ADC CONWAY PLAT

SUMMARY

BOUNDARY SURVEY

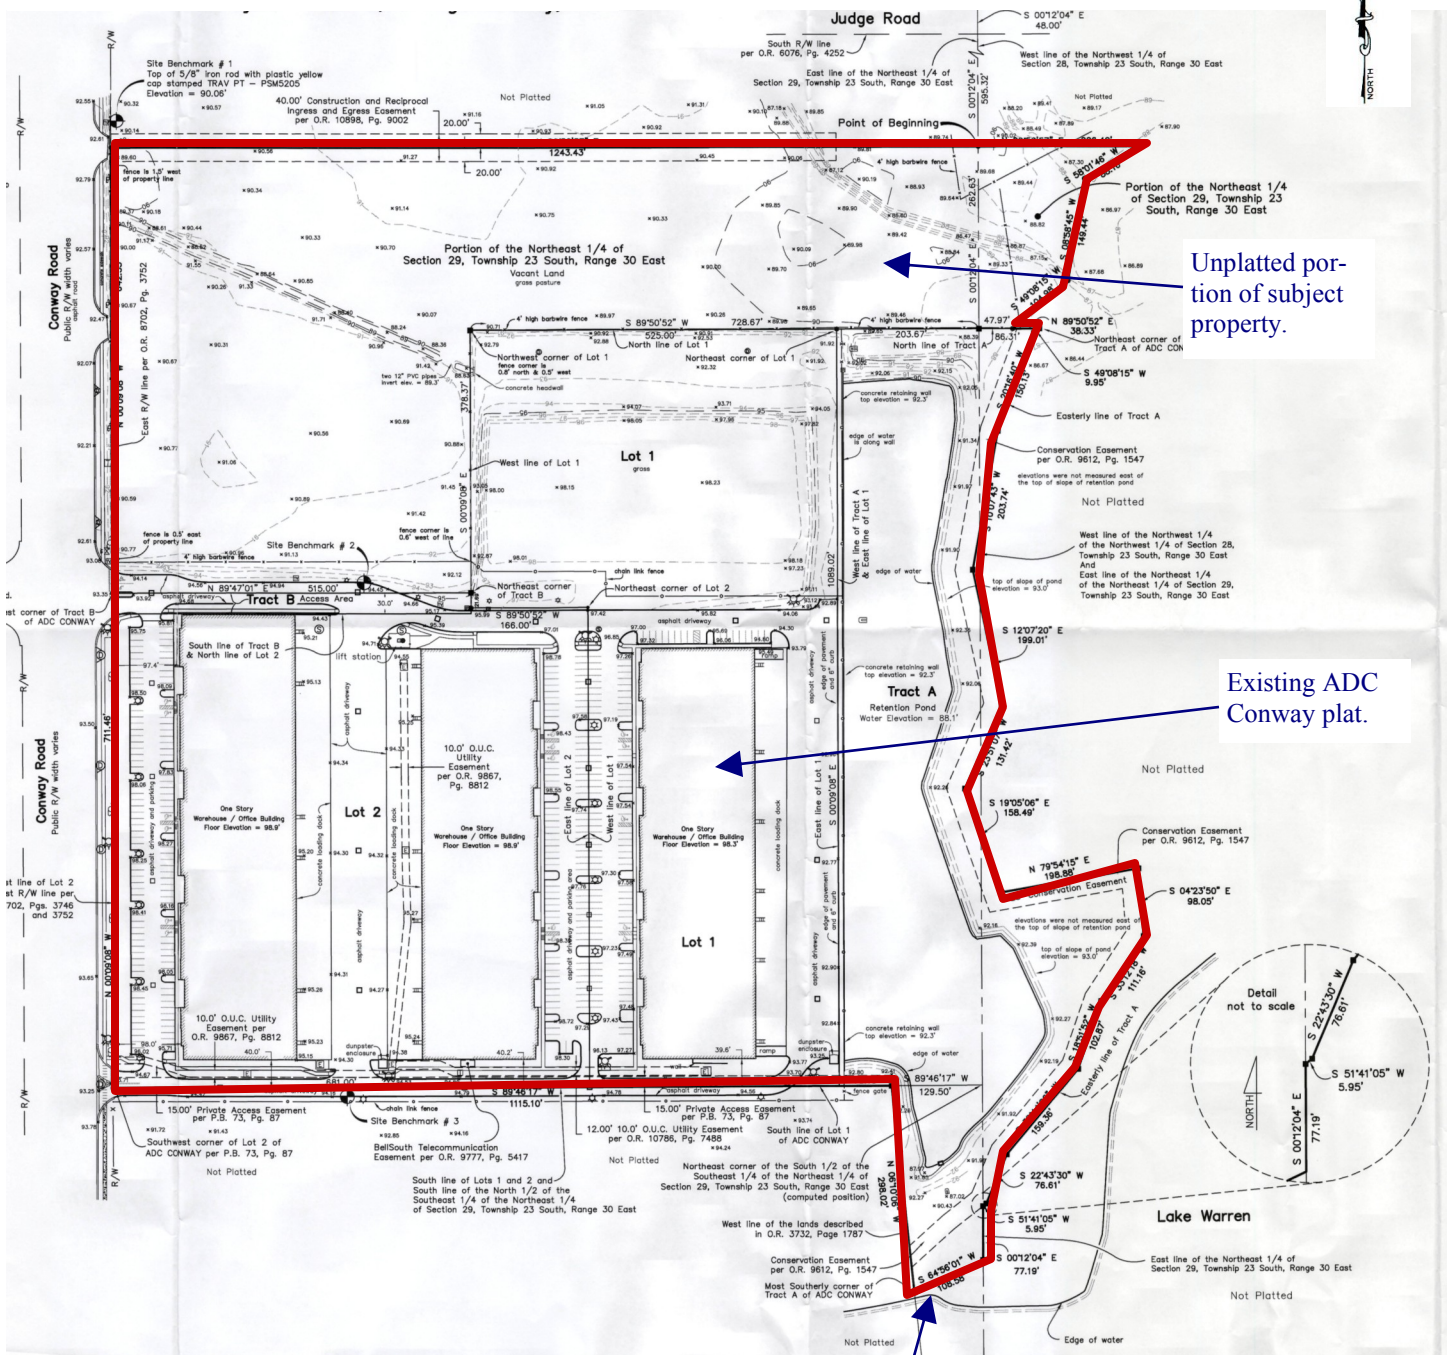
1. Sheet: (Survey) The type, direction, size, and elevation information is missing of drainage and sanitary structures.
2. Sheet: (Survey) The tree location, type and size of all 4" (dia.) and larger trees are missing.

3. Sheet: (Survey) The scaled or approximate location of the .02% and AE zones information are missing.
4. Sheet: (Plat) In the Dedication block, if the owner intends to dedicate nothing to the public it must be stated as, does hereby dedicate nothing to the public or something to that effect.

PROPOSED PLAT

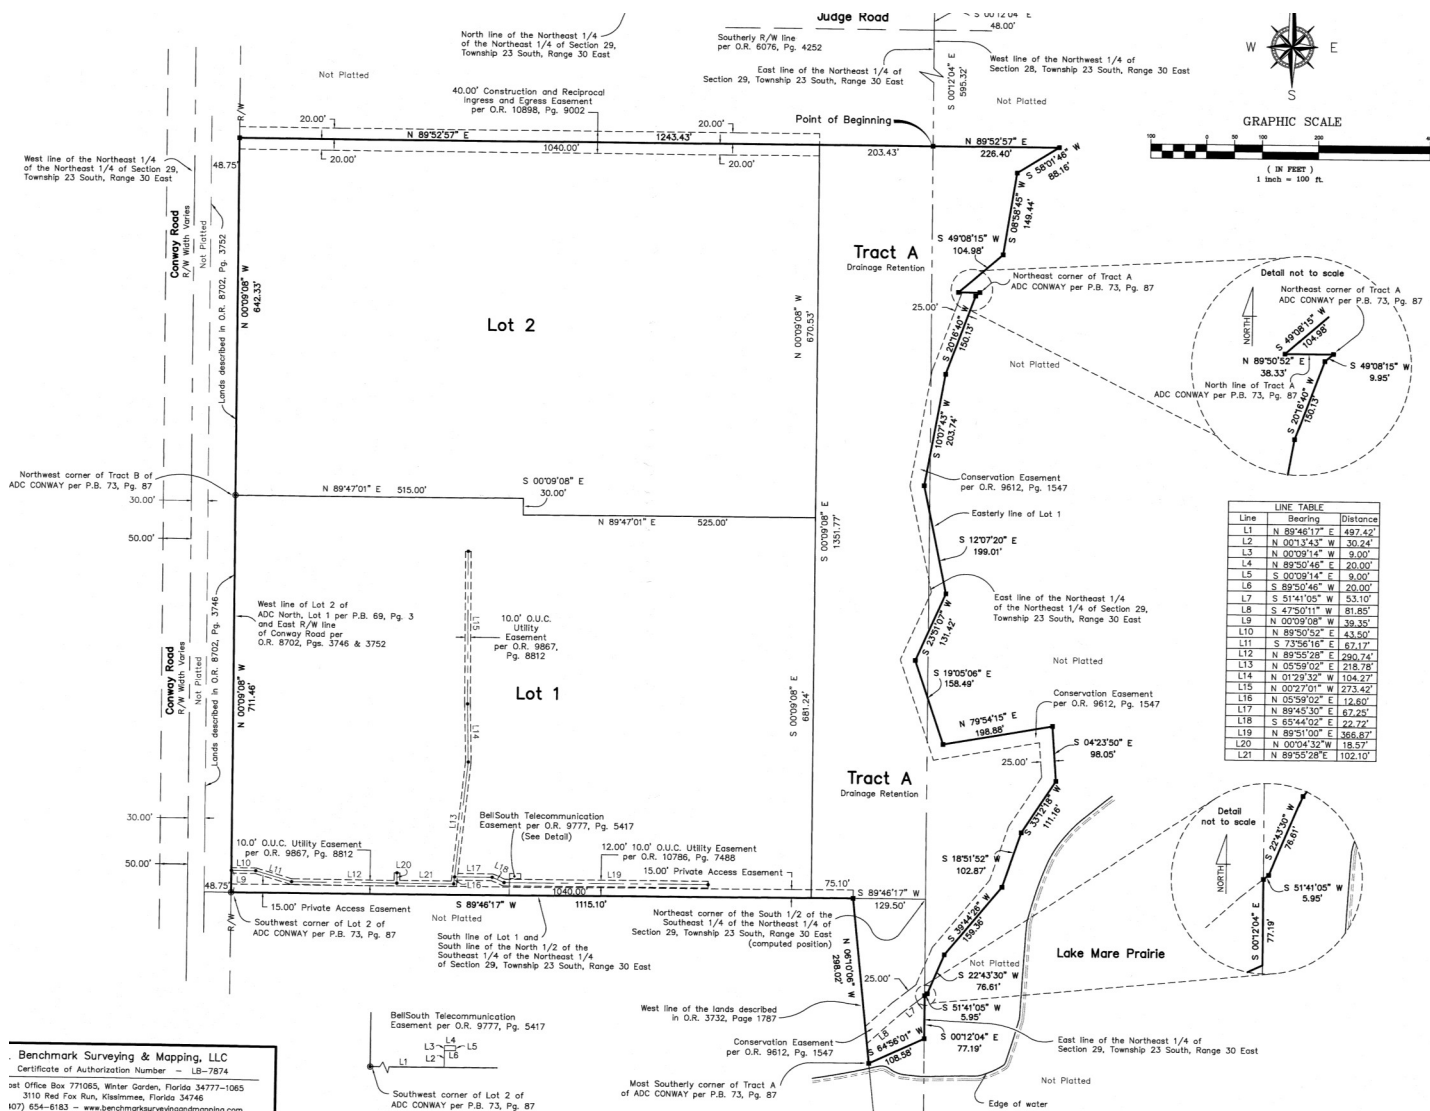
1. The statute requires "how known" language must be added to the notary block in the dedication.
2. Confirm the page number of the easement in note 5.
